CERTIFICATE OF APPROPRIATENESS

Property: 7514 Glenheath St, lot 38, block 67, Glenbrook Valley Sec 7 EXTN Subdivision. The property includes a one-story single-family residence and a detached garage situated on a 12,177 square foot interior lot.

Proposal: New Construction – Carport

PROJECT DETAILS

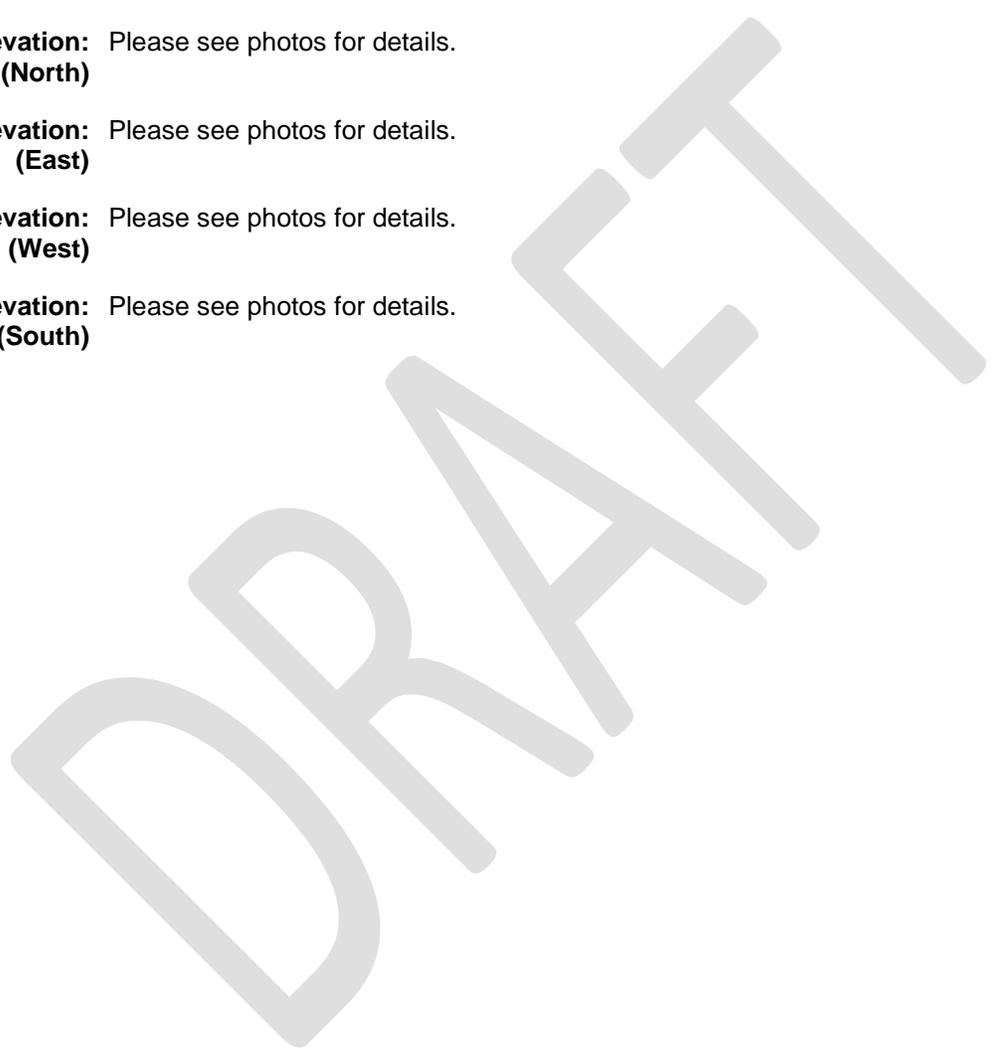
7514 Glenheath: The application for the Certificate of Appropriateness for an attached car port is incomplete and not approveable. However, the incomplete application suggests that the carport is at least 10 feet high which is not compatible with the typical proportions and scale of existing contributing structures. Additionally, the carport may extend over the 5 foot side setback which would be a deed restriction violation.
